SUBJECT: COMANCHE PEAK NUCLEAR POWER PLANT, UNITS 3 AND 4
DOCKET NUMBERS 52-034 AND 52-035
SUBMITTAL OF INFORMATION DISCUSSED DURING GEOLOGY
SAFETY SITE VISIT

Enclosure: Extent of Excavation and Explanation of how the SSI Accommodates the Subsurface Material

Extent of Excavation and Explanation of how the SSI Accommodates the Subsurface Material

FIGURE 1. PROPOSED EXCAVATION FOR US APWR CPNPP

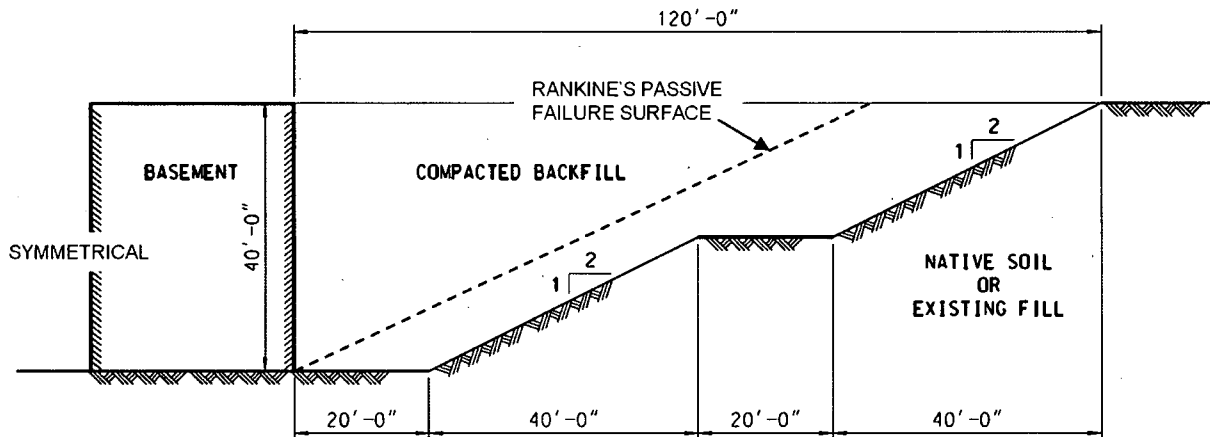
1. Geometric Criterion - requiring a safe slope (2H to 1V in native soil or existing fill is considered a safe slope for a temporary excavation), with presence of benches every 20 ft in elevation and enough room around the structure for formwork and dewatering operations. The sketch in Figure 1 illustrates these requirements. Note: This criterion is being considered with respect to areas with native soil or existing fill. As permitted in FSAR Subsection 2.5.4.5.2, steeper slopes may be used where rock is cut.

2. Stability Criterion - when subjected to dynamic loads, the structure may be acted on by active pressure plus dynamic surcharge on one side and by passive pressure minus dynamic surcharge on the opposite side. As it is understood that native soil/existing fill is weaker than the compacted backfill to be placed in the excavation, the size of excavation in the horizontal direction must ensure containment of the passive wedge within the compacted backfill. Under the assumptions of Rankine's Theory, the minimum extension of the excavation at grade (L) is:

This value is less than $L = 120$ ft resulting from the first criterion, and the Rankine's passive failure surface is contained within the compacted backfill.
